ORIGINATION FORM

Proposed Revisions to a Standard Plans Index

Index Number: 700-040

Index Title: Cantilever Sign Structure

LAST REVISION 11/01/21	DESCRIPTION: 11/01/22	FDOT FY 2022-23 STANDARD PLANS	CANTILEVER SIGN STRUCTURE	INDEX 700-040	SHEET 2 of 5
---------------------------	--------------------------	--------------------------------------	---------------------------	------------------	-----------------

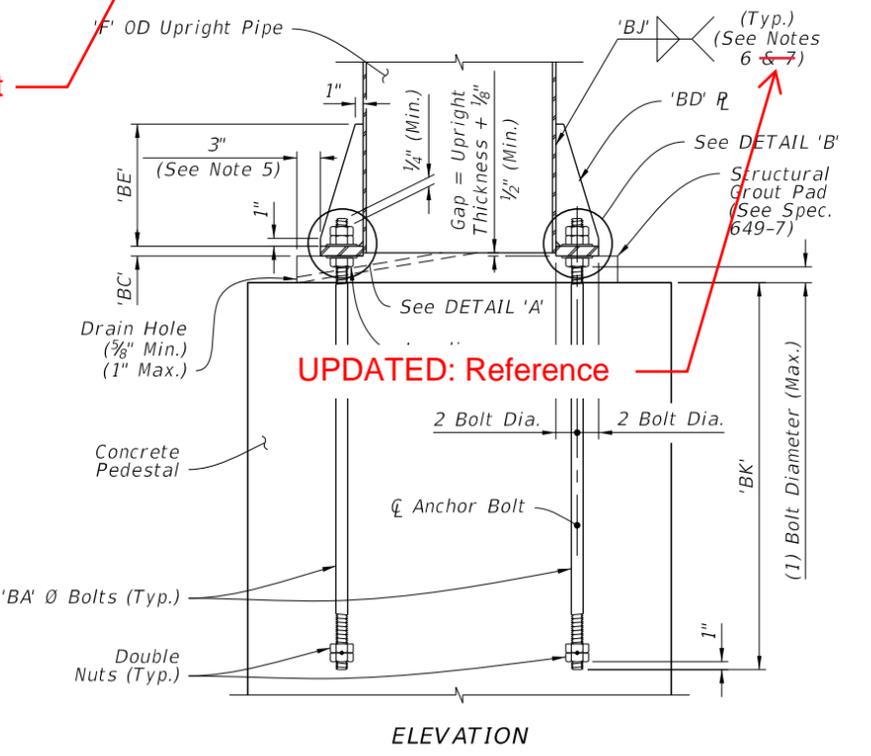
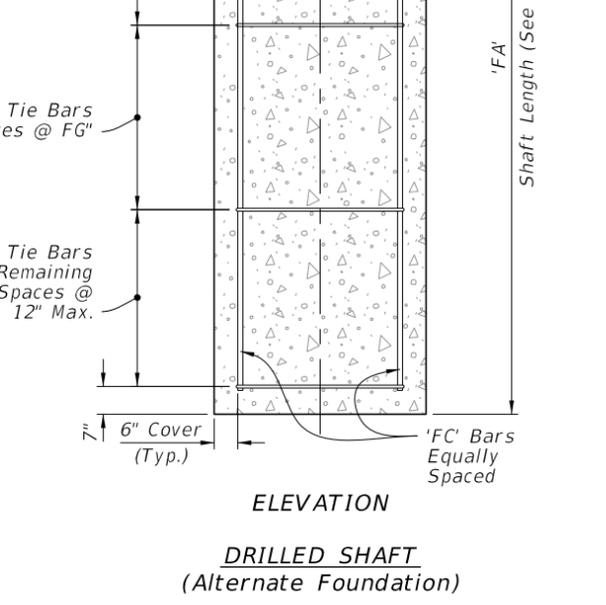
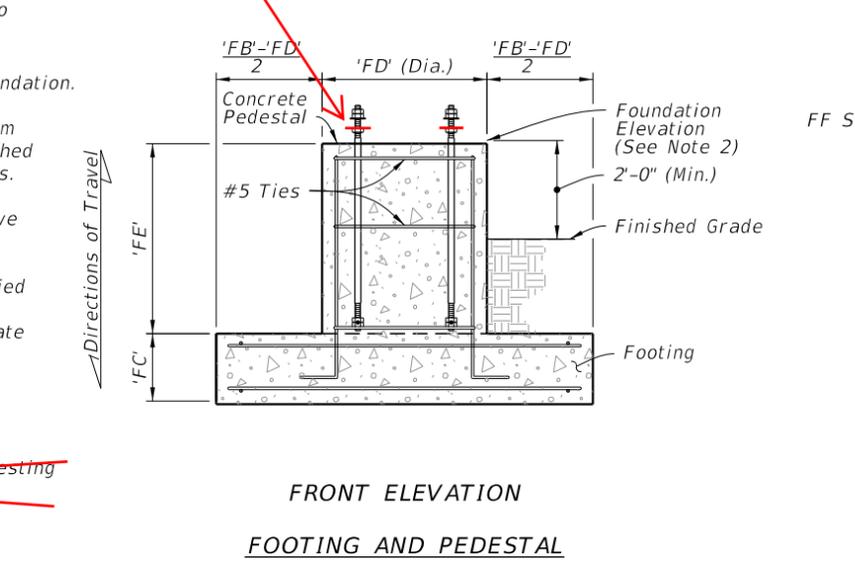
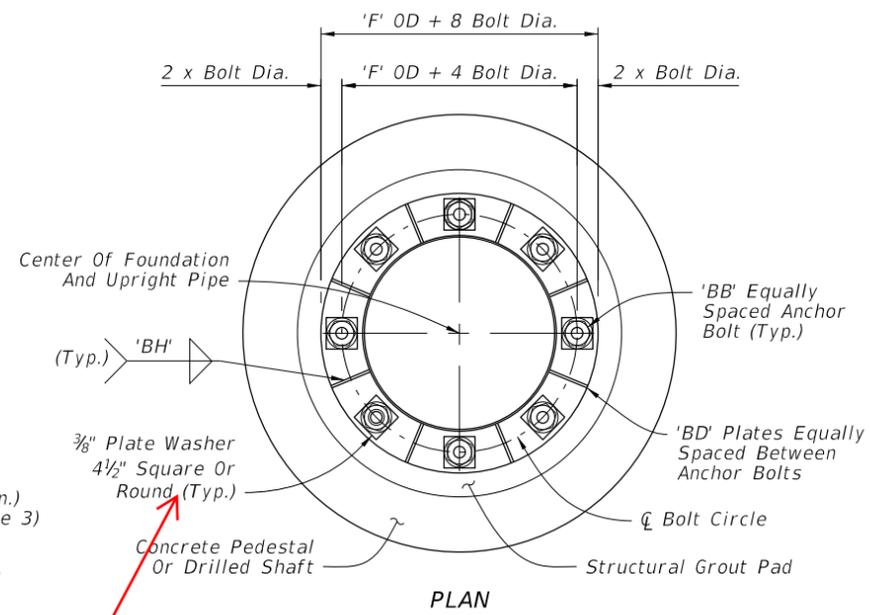
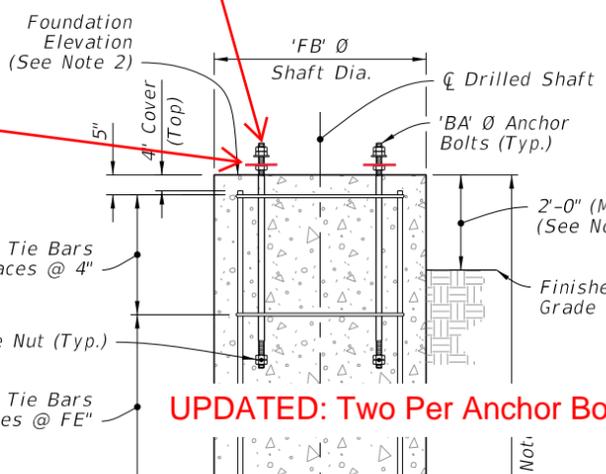
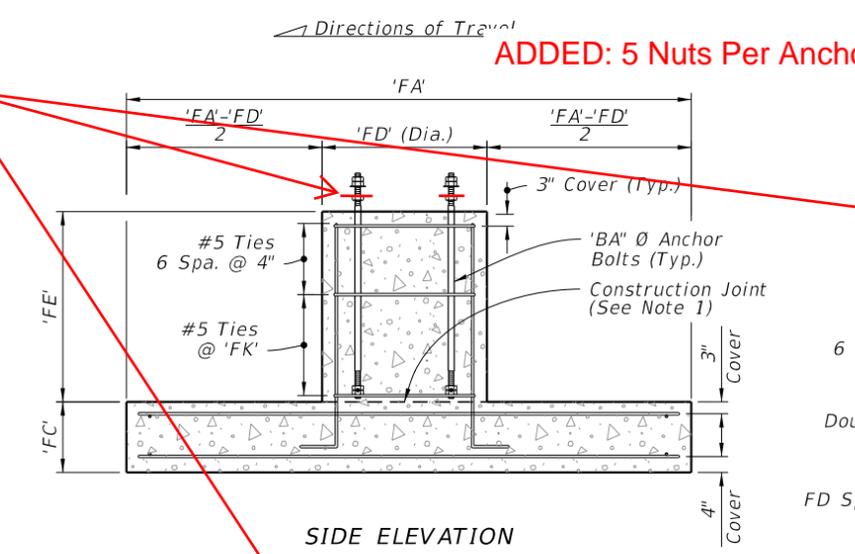
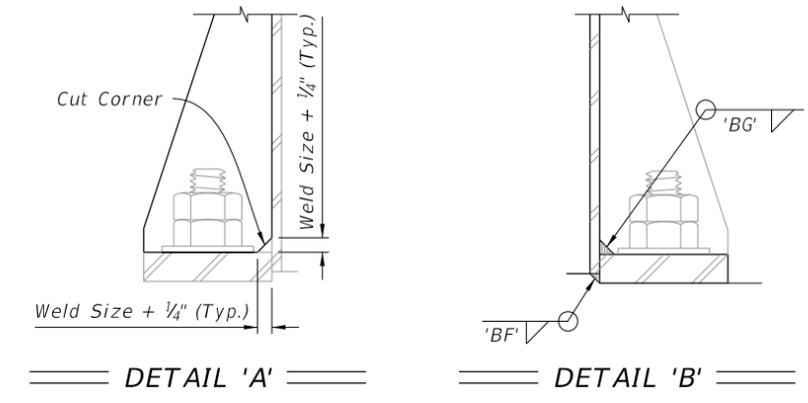
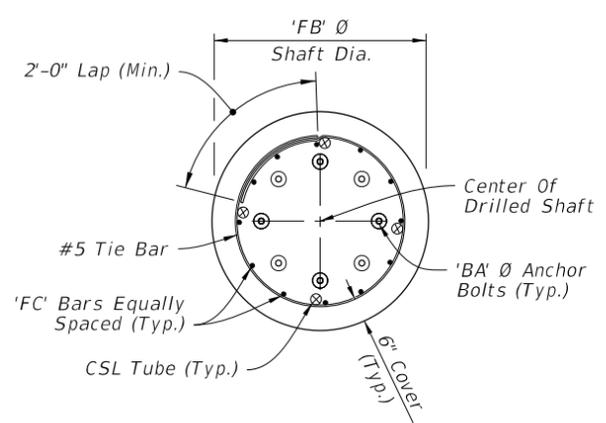
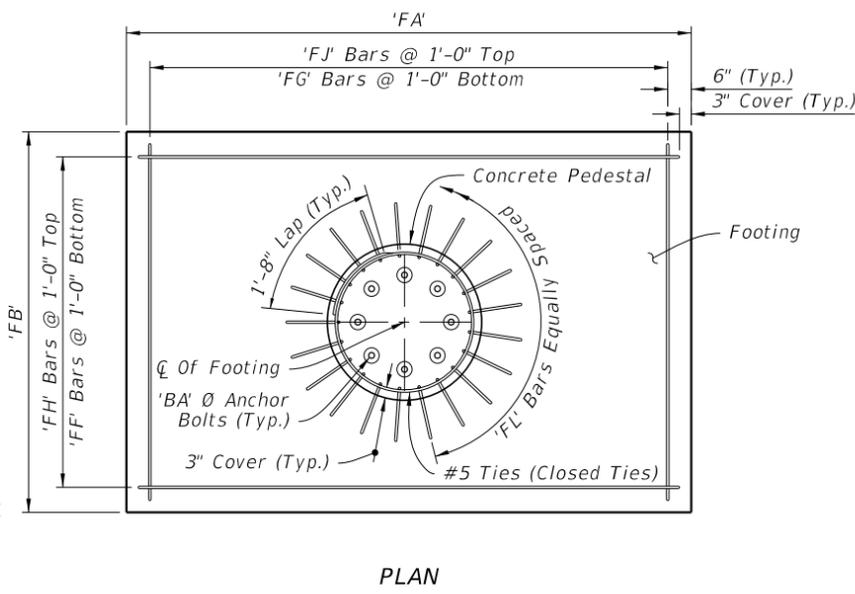
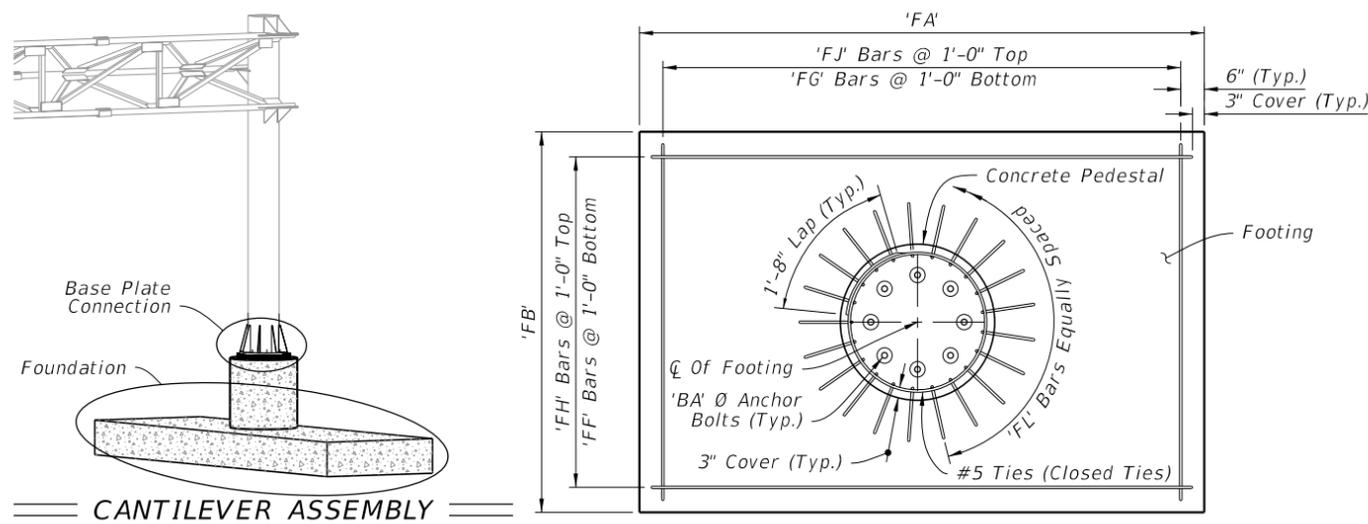
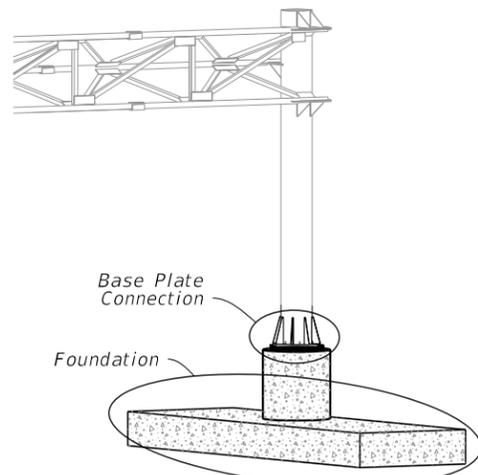
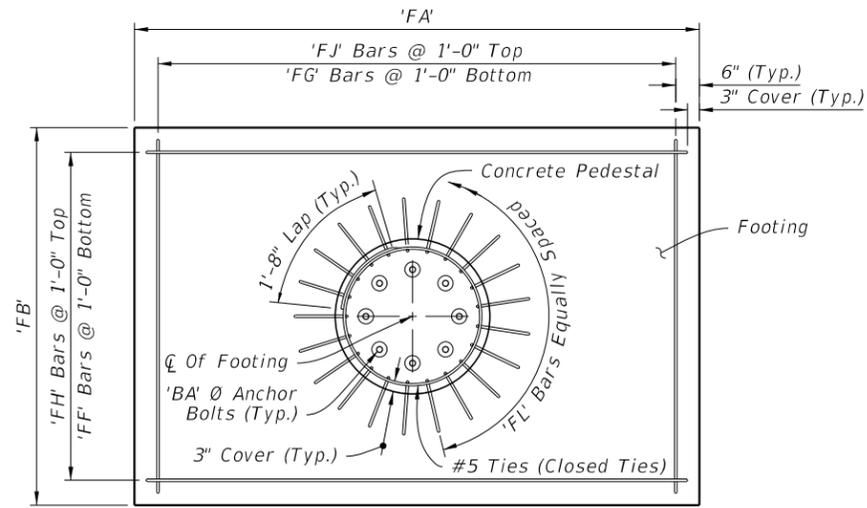
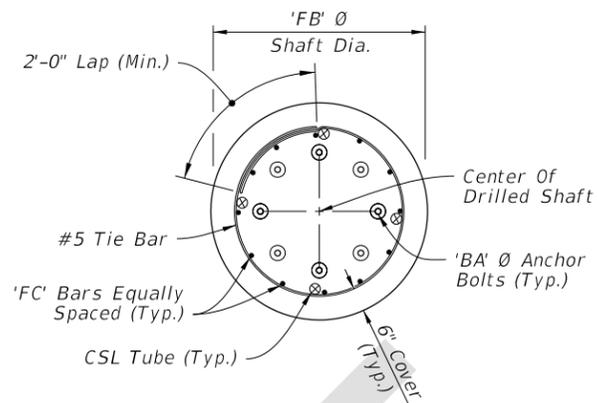
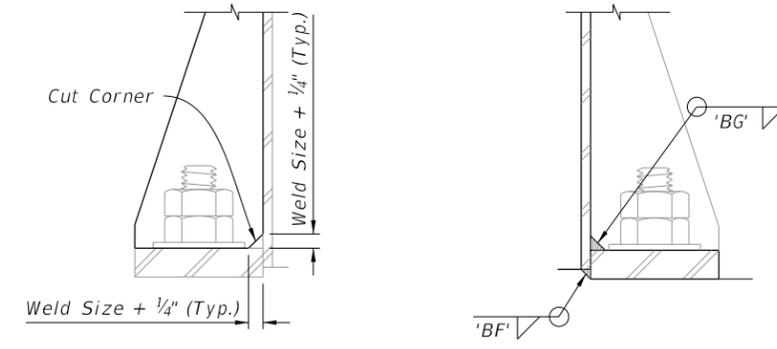
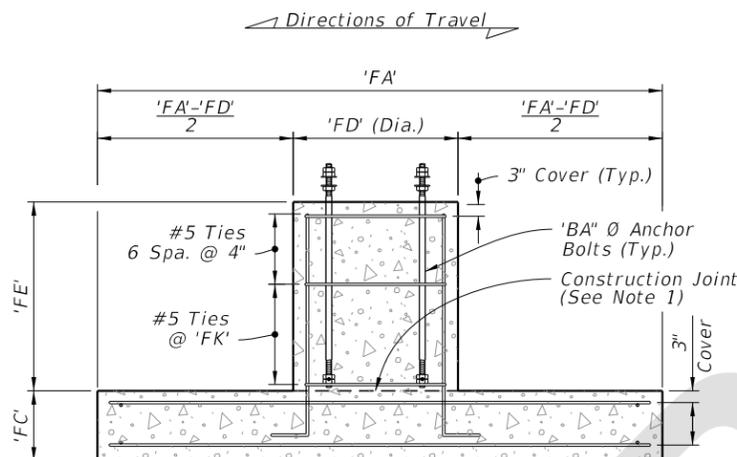
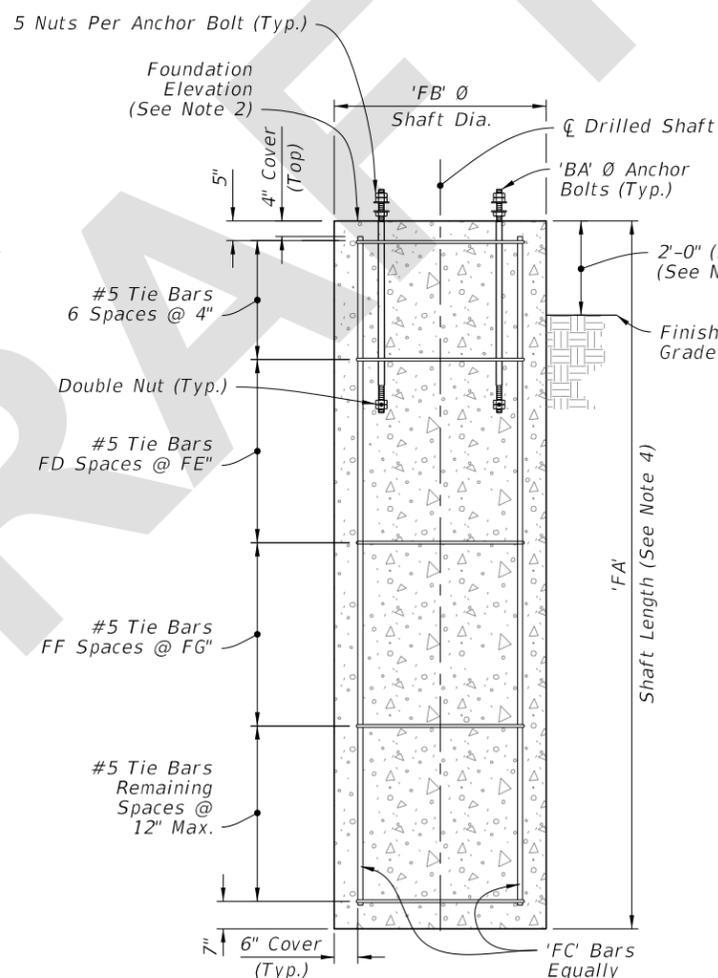
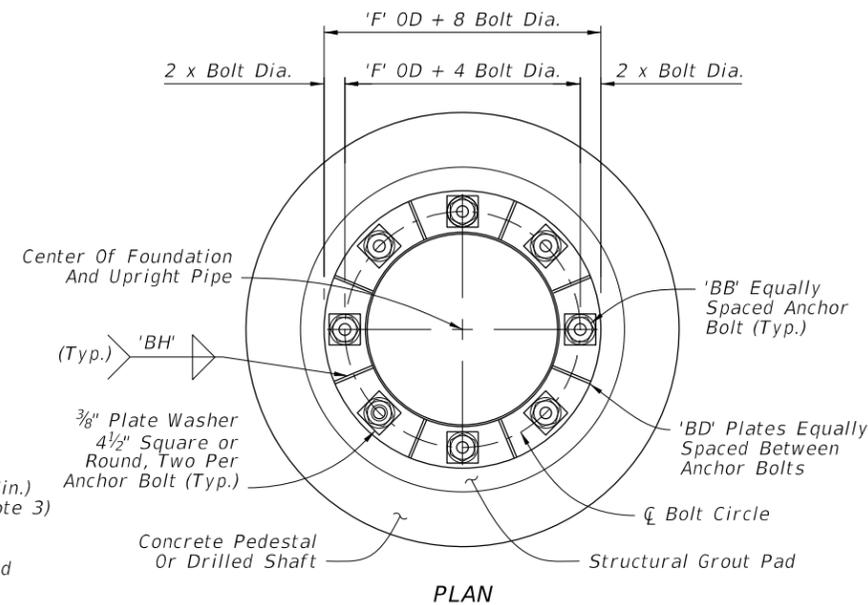
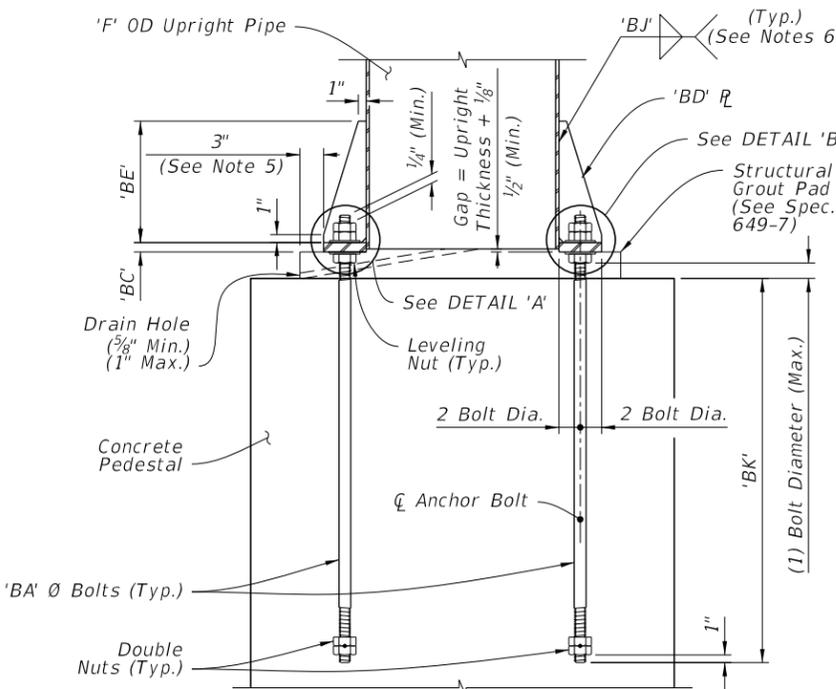
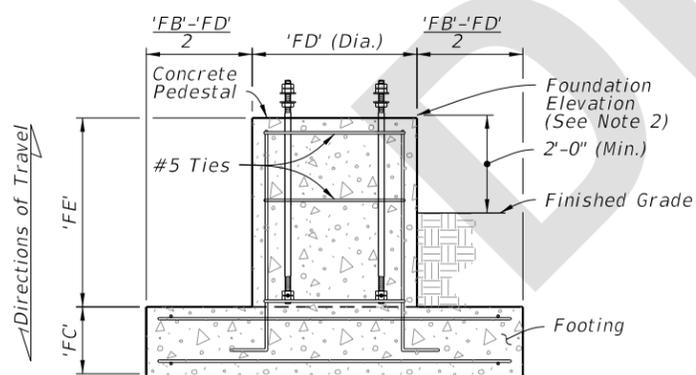
Sheet 2: Deleted Note 7 ; Added Plate Washers to the Anchor Bolts and new callout "5 Nuts Per Anchor Bolt (Typ.)"; in the FOUNDATION details; Updated the Plate Washer callout and the weld references in the BASE PLATE CONNECTION details; Added new note detailing the weld pattern of the 'BD' plates indicating that they should be welded in a star pattern.

Sheet 2: New Note - This process is to help prevent residual stress buildup in base plate connection to prevent cracking.

DELETED

ADDED: 5 Nuts Per Anchor Bolt (Typ.)

ADDED: Washers

UPDATED: Two Per Anchor Bolt

UPDATED: Reference

- Wrap fillet weld around the stiffener termination on the tube wall.
 - Weld plates 'BD' in a star pattern. A star pattern is one in which the plates on opposite and near opposite sides of the pole circle are successively welded in a pattern resembling a star. For an 8 plate circle with plates sequentially numbered 1 to 8, weld the plates in the following order: (1, 5, 7, 3, 8, 4, 6, 2).

LAST REVISION 11/01/17	DESCRIPTION: 11/01/22
--------------------------------------	---------------------------------

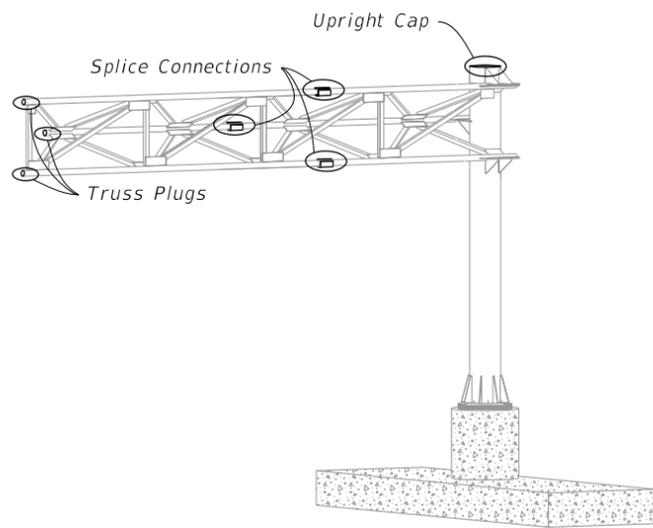
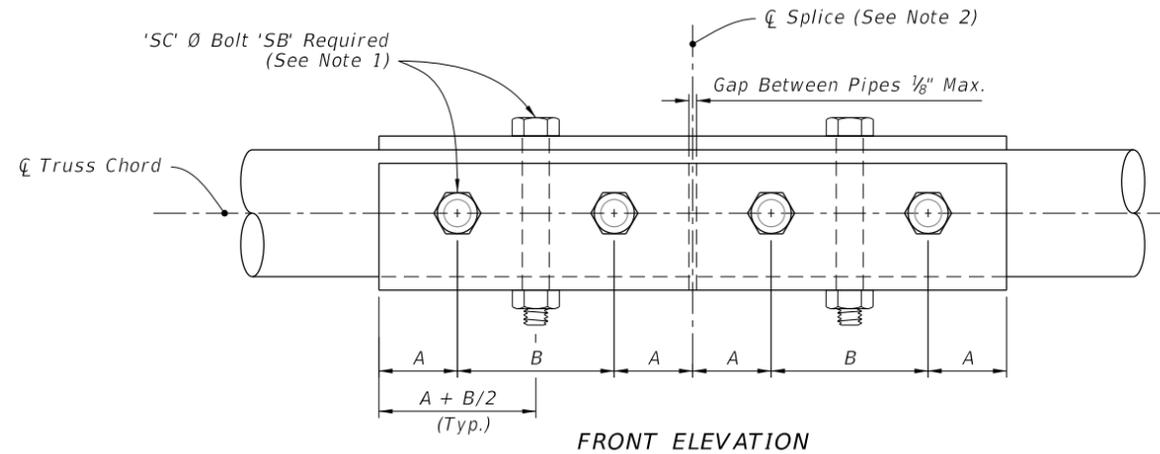
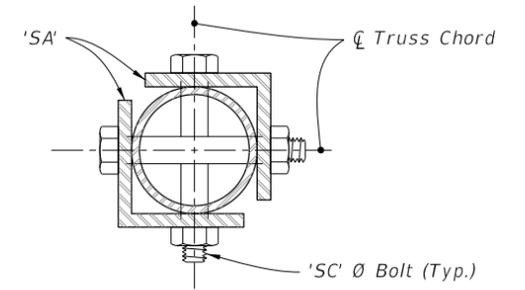
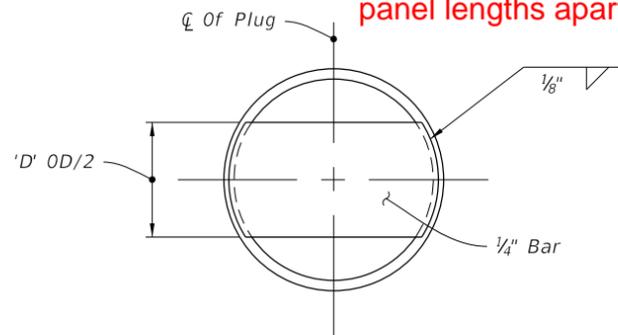
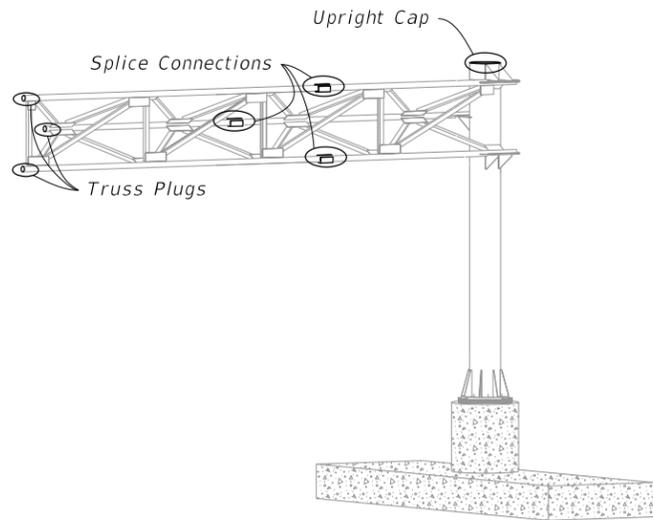
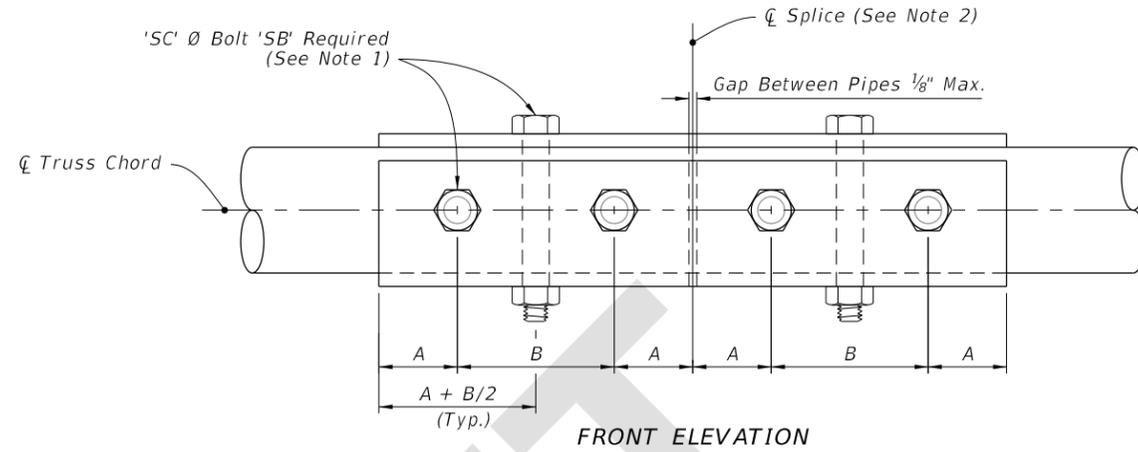
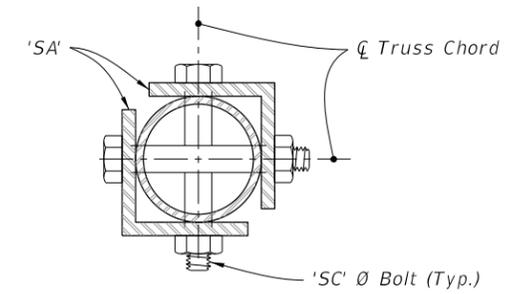
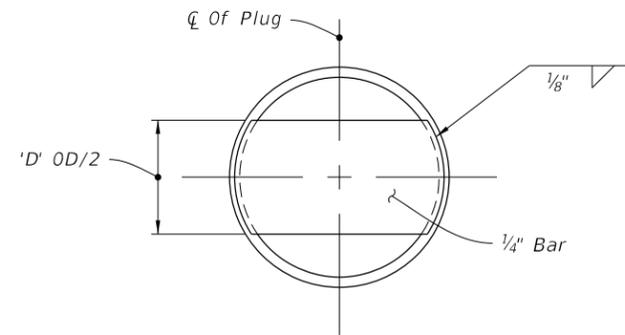
Sheet 5: Added General Note 5.B as New Note 3 - "Chord Splices: "SD" Panel from upright is the closest panel in which chord splice may be used. See Plans for CANTILEVER SIGN STRUCTURE DATA TABLE. Minimum splice spacing is two truss panel lengths apart."

ADDED NOTE 3:
 Chord Splices: "SD" Panel from upright is the closest panel in which chord splice may be used. See Plans for CANTILEVER SIGN STRUCTURE DATA TABLE. Minimum splice spacing is two truss panel lengths apart

1. Only 6 bolts are shown in detail for clarity. (One Half Each Side Of Splice)
2. Splices are not permitted for trusses less than or equal to 40', Splice optional for trusses greater than 40'.
3. Chord Splices: "SD" Panel from upright is the closest panel in which a chord splice may be used. See Plans for CANTILEVER SIGN STRUCTURE DATA TABLE. Minimum splice spacing is two truss panel lengths apart.
